ARCHITECTURAL REVIEW BOARD STAFF REPORT

Project #/Name	SP-2025-03: Flow Honda/CDJR Outdoor Storage, Display, and Sales Expansion
Review Type	Advisory Review for a Special Use Permit
Parcel Identification	04500-00-00-068D4
Location	960 Seminole Trail
Zoned	Highway Commercial (HC) / Entrance Corridor (EC) / Airport Impact Area (AIA)
Owner/Applicant	Flow 960 Hilton LLC / Shimp Engineering (Julia Moore)
Magisterial District	Rio
Proposal	To amend an existing Special Use Permit (SP2002-46) to expand the outdoor storage/display/sales area located in front of the Flow Honda/CDJR building at 960 Seminole Trail.
Context	The Flow Honda/CDJR site is located in the heavily developed Rt. 29 commercial corridor. The Honda/CDJR building is located just north of the Flow Subaru (previously Umansky) building. A Walmart is situated to the south across Hilton Heights Rd. Just beyond Walmart is the Malloy Chevrolet auto dealership. To the west is Sam’s Club, and a DoubleTree hotel is located to the north. A variety of commercial buildings stand on the opposite side of Rt. 29. (Fig. 1.)

Figure 2: Proposed concept plan identifying new vehicle display areas, existing display areas that are to be converted to parking, and existing parking that is to remain.

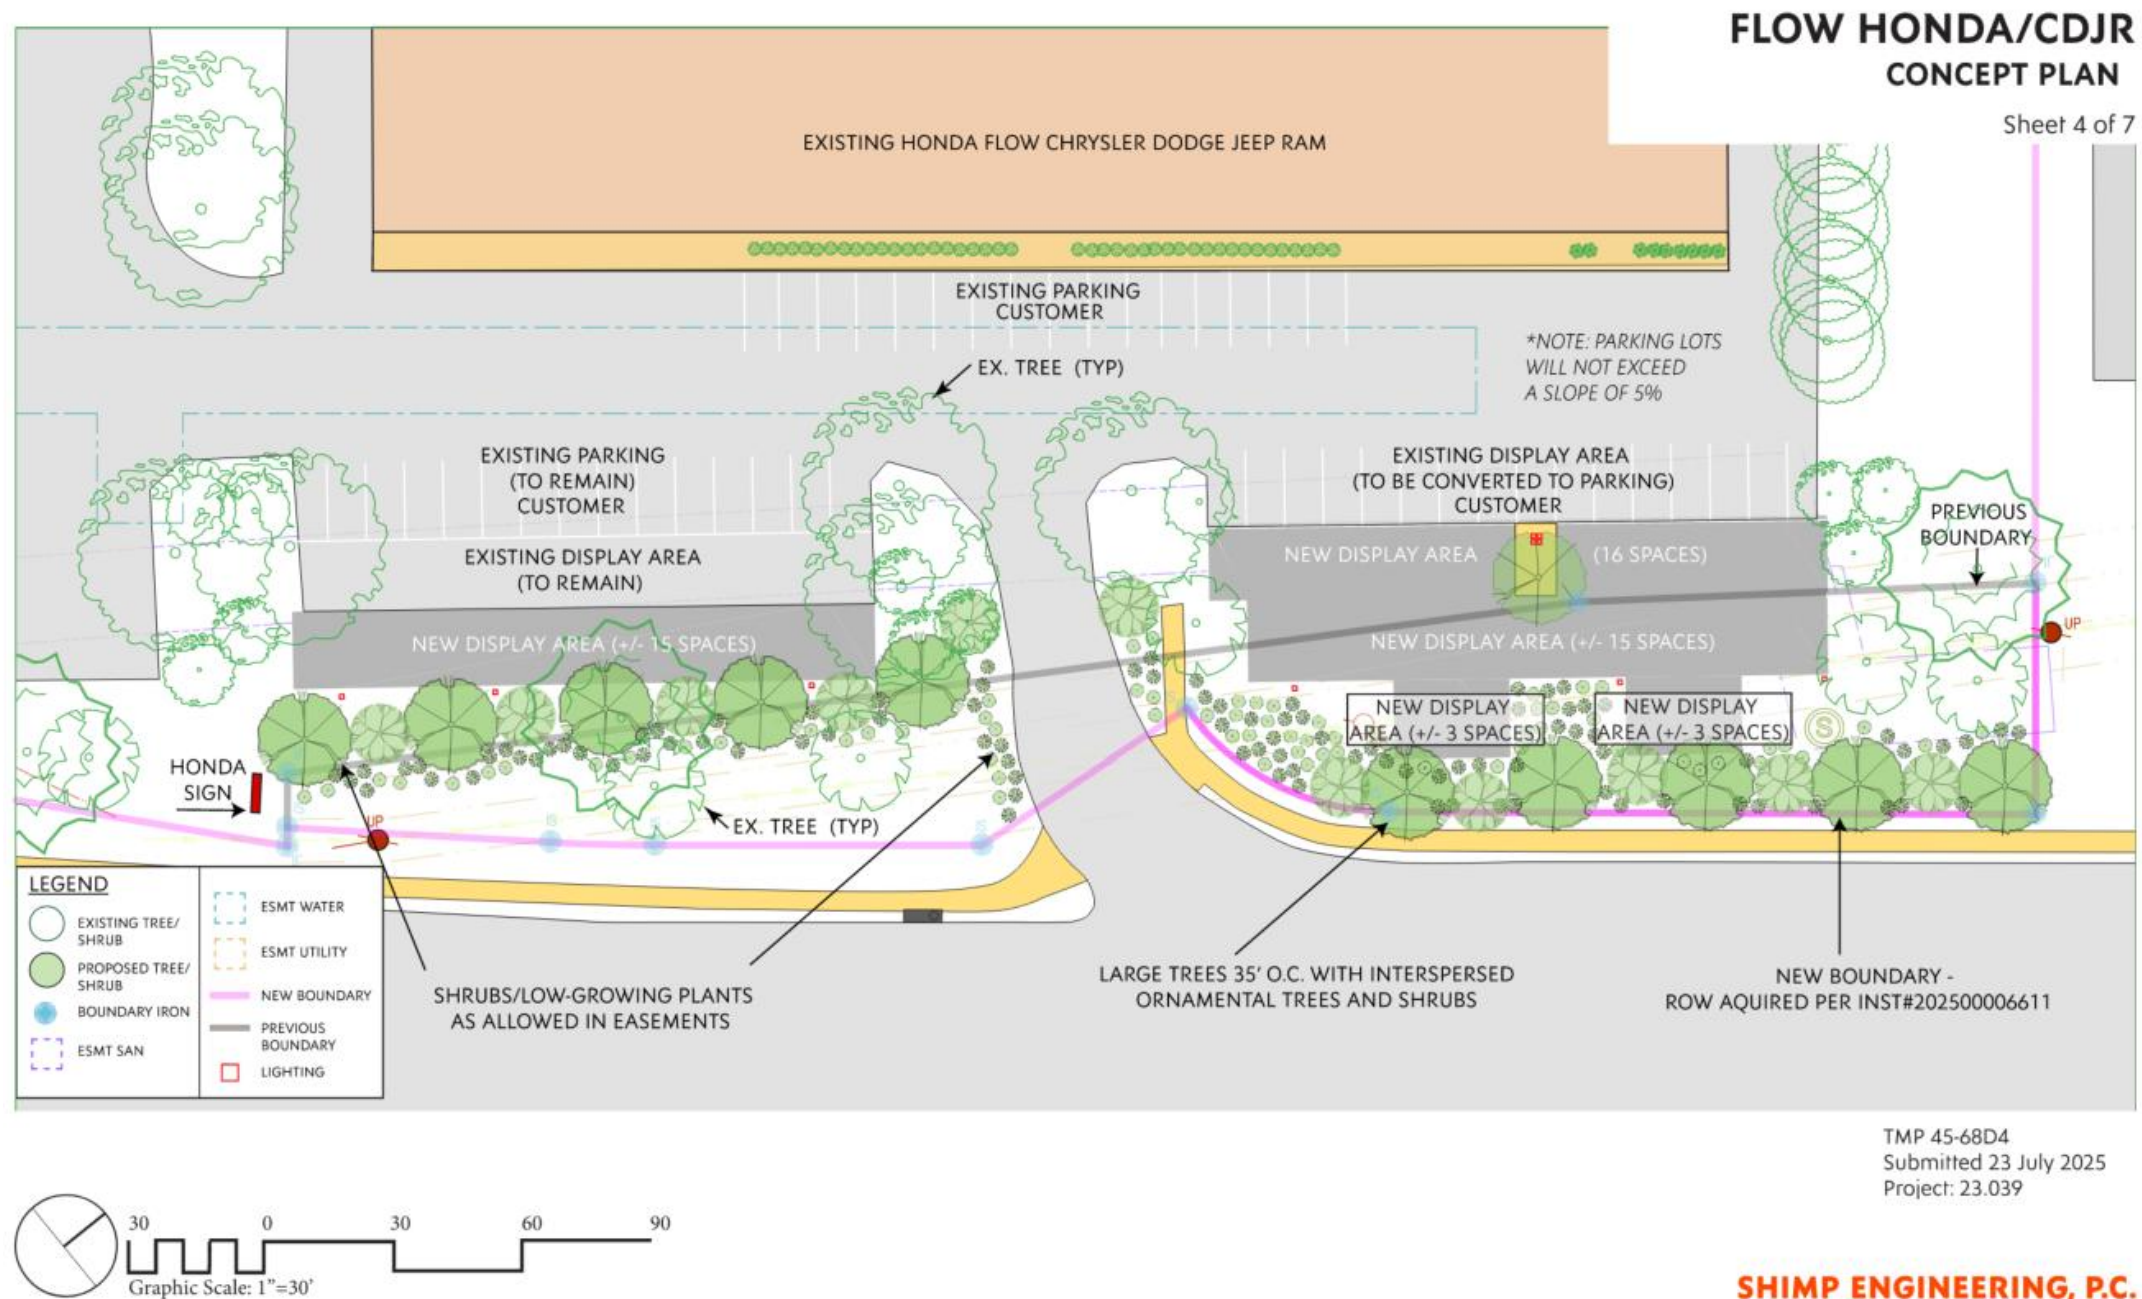
8	Continuity within the Entrance Corridor should be obtained by planting different types of plant materials that share similar characteristics. Such common elements allow for more flexibility in the design of structures because common landscape features will help to harmonize the appearance of development as seen from the street upon which the Corridor is centered.	The current paved area measures between 73 and 78 feet from the edge of the pavement. The proposed concept plan shows that the display parking area will be expanded by approximately 8,355 square feet. This will be done by converting a portion of the existing landscaped area along the frontage into paved parking, which will include triple-stacked parking arrangements on both the northern and southern sides of the right-in entrance. North of the entrance, the proposed display extends towards the EC with two paved “bumpouts” accommodating approximately 6 additional vehicles. This brings the display parking within 25’ of the edge of pavement. The existing display spaces north of the entrance will be converted to customer parking.

32	Landscaping along the frontage of Entrance Corridor streets should include the following: a. Large shade trees should be planted parallel to the Entrance Corridor Street. Such trees should be at least 3½ inches caliper (measured 6 inches above the ground) and should be of a plant species common to the area. Such trees should be located at least every 35 feet on center. b. Flowering ornamental trees of a species common to the area should be interspersed among the trees required by the preceding paragraph. The ornamental trees need not alternate one for one with the large shade trees. They may be planted among the large shade trees in a less regular spacing pattern. c. In situations where appropriate, a three or four-board fence or low stone wall, typical of the area, should align the frontage of the Entrance Corridor street. d. An area of sufficient width to accommodate the foregoing plantings and fencing should be reserved parallel to the Entrance Corridor street, and exclusive of road right-of-way and utility easements.	Conceptual landscaping is included on the concept plan. The area subject to the special use permit (see sheet 7 of Attachment 2) has approximately 355’ of frontage along the EC and utilities – both underground and overhead – are in place along the frontage, further limiting the available planting area. The concept plan shows large shade trees with ornamental trees and shrubs interspersed behind the overhead line (labeled in yellow) south of the right-in entrance and in front of the overhead line north of this entrance. The proposed large trees south of the entrance seem to conflict with existing trees designated to remain. Additionally, the arrangement of shrubs along the southern edge of the entrance and in the planting area to the north appears random and uncoordinated. While this layout generally satisfies the frontage planting requirements and is expected to mitigate the visual impact of the expansion of paved area on the EC, it requires better coordination with the

existing landscaping and more refinement of the arrangement of proposed landscaping. The layout shown in the concept plan provides sufficient planting area to avoid conflicts with existing utilities.	
33	Landscaping along interior roads: a. Large trees should be planted parallel to all interior roads. Such trees should be at least 2½ inches caliper (measured six inches above the ground) and should be of a plant species common to the area. Such trees should be located at least every 40 feet on center.	There are no existing or proposed interior roads within this site.	None.
35	Landscaping of parking areas: a. Large trees should align the perimeter of parking areas, located 40 feet on center. Trees should be planted in the interior of parking areas at the rate of one tree for every 10 parking spaces provided and should be evenly distributed throughout the interior of the parking area. b. Trees required by the preceding paragraph should measure 2½ inches caliper (measured six inches above the ground); should be evenly spaced; and should be of a species common to the area. Such trees should be planted in planters or medians sufficiently large to maintain the health of the tree and shall be protected by curbing. c. Shrubs should be provided as necessary to minimize the parking area's impact on Entrance Corridor streets. Shrubs should measure 24 inches in height.	There are existing trees that are to remain along the northern perimeter of the site that meet the perimeter parking area requirements. The proposal does not appear to meet the requirement for interior parking trees. Approximately 52 new parking spaces are proposed, requiring an additional 5 trees, but only one interior tree has been added. The trees located north and south of the right-in entrance, as well as those along the northern perimeter of the site, compensate for the absence of interior trees in the expanded paved area. Additionally, the arrangement of trees and shrubs along the front of the site is expected to effectively filter the view of the additional display spaces, reducing the necessity for trees within the paved area itself.	None.

Development pattern		
	Site development and layout		
6	Site development should be sensitive to the existing natural landscape and should contribute to the creation of an organized development plan. This may be accomplished, to the extent practical, by preserving the trees and rolling terrain typical of the area; planting new trees along streets and pedestrian ways and choosing species that reflect native forest elements; ensuring that any grading will blend into the surrounding topography thereby creating a continuous landscape; preserving, to the extent practical, existing significant river and stream valleys which may be located on the site and integrating these features into the design of surrounding development; and limiting the building mass and height to a scale that does not overpower the natural settings of the site, or the Entrance Corridor.	No changes are proposed to the layout of the existing showroom building, travelway, and pedestrian and vehicular connections. In addition to landscaping, there are a few standard practices related to the display of vehicles that can help reduce visual impacts. Over the years, the ARB has developed a standard recommended condition of approval for vehicle display that requires vehicles not be elevated anywhere on site. This means that vehicles cannot be displayed on ramps, turntables, or on other similar equipment or by other similar methods. This helps maintain an appropriate, organized, and orderly appearance on site.	Standard conditions of approval for outdoor display are recommended: Vehicles must be displayed or stored only in areas indicated for display or storage on the Concept Plan. Vehicles must be parked in striped parking spaces.

39	The relationship of buildings and other structures to the Entrance Corridor street and to other development within the corridor should be as follows: a. An organized pattern of roads, service lanes, bike paths, and pedestrian walks should guide the layout of the site. b. In general, buildings fronting the Entrance Corridor street should be parallel to the street. Building groupings should be arranged to parallel the Entrance Corridor street. c. Provisions should be made for connections to adjacent pedestrian and vehicular circulation systems. d. Open spaces should be tied into surrounding areas to provide continuity within the Entrance Corridor. e. If significant natural features exist on the site (including creek valleys, steep slopes, significant trees, or rock outcroppings), to the extent practical, then such natural features should be reflected in the site layout. If the provisions of Section 32.5.2.n of the <i>Albemarle County Zoning Ordinance</i> apply, then improvements required by that section should be located so as to maximize the use of existing features in screening such improvements from Entrance Corridor streets. f. The placement of structures on the site should respect existing views and vistas on and around the site.	The ARB has also required that storage/display/sales spaces must be striped like standard parking spaces. This allows a distribution and orientation of parked cars that is more like standard parking lots, helps ensure a consistent appearance over time, and it makes it easier to assess conformity with the approved plan. The incorrect application number for the previously approved special use permit is noted on sheets 6 and 7 of the concept plan. The incorrect application number for the current special use permit is noted throughout the concept plan. The area of proposed amendment boundaries shown on sheets 6 and 7 of the concept plan extends beyond where	Vehicles must not be elevated anywhere outside of a building on site. Revise the concept plan to note the correct SP number (SP-2002-46) that is being amended. Revise the concept plan to note the correct SP number (SP-2025-03) under review. Revise the boundaries of the proposed amendment area shown on sheets 6 and 7 of the concept plan to include only the area where changes are proposed.

changes are proposed. Reducing the boundaries to only include the area where changes are proposed would be appropriate.	
	Site Grading		
40	Site grading should maintain the basic relationship of the site to surrounding conditions by limiting the use of retaining walls and by shaping the terrain through the use of smooth, rounded landforms that blend with the existing terrain. Steep-cut or fill sections are generally unacceptable. Proposed contours on the grading plan shall be rounded with a ten-foot minimum radius where they meet the adjacent condition. Final grading should achieve a natural, rather than engineered, appearance. Retaining walls 6 feet in height and taller, when necessary, shall be terraced and planted to blend with the landscape.	There is a gentle change in topography between the showroom building and the EC. Grading is shown to establish the expanded display area; however, this grading is minimal and is not expected to have a negative visual impact on the EC. The slope of the new planting area shown on the site section (Sheet 6 of Attachment 2) appears to be exaggerated.	Revise the site section in the concept plan to show a more accurate representation of the proposed grading.

- 1. Revise the site section in the concept plan to show a more accurate representation of the proposed grading.
- 2. Revise the concept plan to note the correct SP number (SP-2002-46) that is being amended.

3. Revise the concept plan to note the correct SP number (SP-2025-03) under review.
4. Revise the boundaries of the proposed amendment area shown on sheets 6 and 7 of the concept plan to include only the area where changes are proposed.
